## Title: Processes governing the mass balance of Chhota Shigri Glacier (Western Himalaya, India) assessed by point-scale surface energy balance measurements

## Major comments:

Fig1. Orographic barrier (watershed divide) between Chandra and Beas basins.

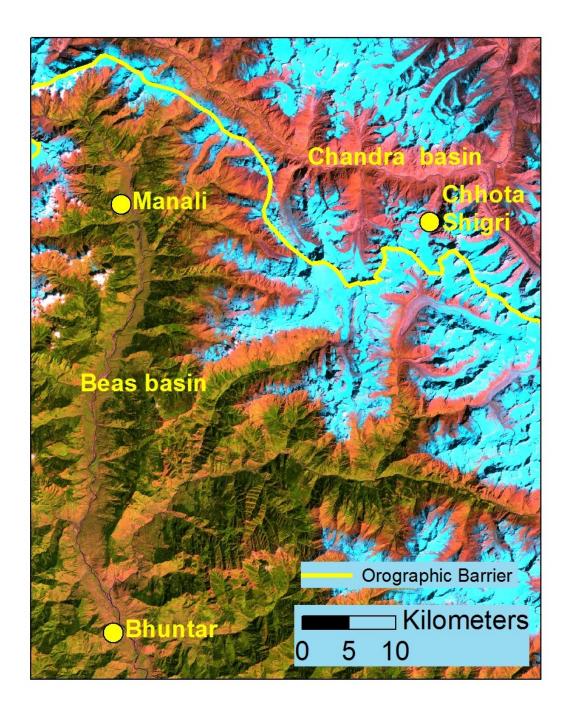
This study presented a point-scale surface energy balance analysis using in-situ meteorological data from the ablation zone of Chhota Shigri Glacier over two separate periods. The impact of Indian summer monsoon on Chhota Shigri Glacier mass balance also assessed. However, there are several misconceptions have given in the manuscript. Most important issue is related with Bunter meteorological data. Authors used meteorological data (Tair and precipitation) of Bhuntar as the representative for the 2012/2013 hydrological year because this station is about 50 km from the Chhota Shigri Glacier. However orographic barrier separate the Beas basin (Bhuntar meteorological station) and Chandra basin (Chhota Shigri Glacier) (Fig 1). Effect of orographic barrier on vegetation distribution and geomorphic process in both basins (Chandra and Beas basins) suggests that Chandra basin is located in monsoon arid zone (monsoon rain shadow area) and Beas basin in monsoon dominated region (Bookhagen et al. 2005; Collins and Hasnain 1995; Srivastava et al. 2013). Thus, is it scientifically correct to use summer monsoon dominate station metrological data as a hydrological representative for Chhota Shigri Glacier which is located in monsoon-arid transition zone? Authors also mentioned on Page 2877, line 16-21 'the winter westerlies predominantly undergo orographic capture at higher elevations in the orogenic interior providing high precipitations at Chhota Shigri Glacier (79% of annual precipitation) compared to Bhuntar meteorological station in windward side (49% of annual precipitation). Thus, Chhota Shigri Glacier seems to be a winter-accumulation type glacier receiving most of its annual precipitation during winter season.' If the precipitation pattern by ISM and MLW is highly variable between Chhota Shigri base camp and Bhuntar meteorological stations (i.e inside the airport, and just 4 kilometers from the confluence of Beas and Parbati Rivers) then the question rises here, how valid is the re-constructed mass balance for Chhota Shigri Glacier (monsoon-arid zone) using meteorological data of Bhuntar station (monsoon dominated region) (Azam et al. 2014 AoG paper)? Authors have also hid orographic barrier on map in Azam et al. 2014 TCD and Azam 2014 AoG. We believe this is questionable and this can mislead the readers.
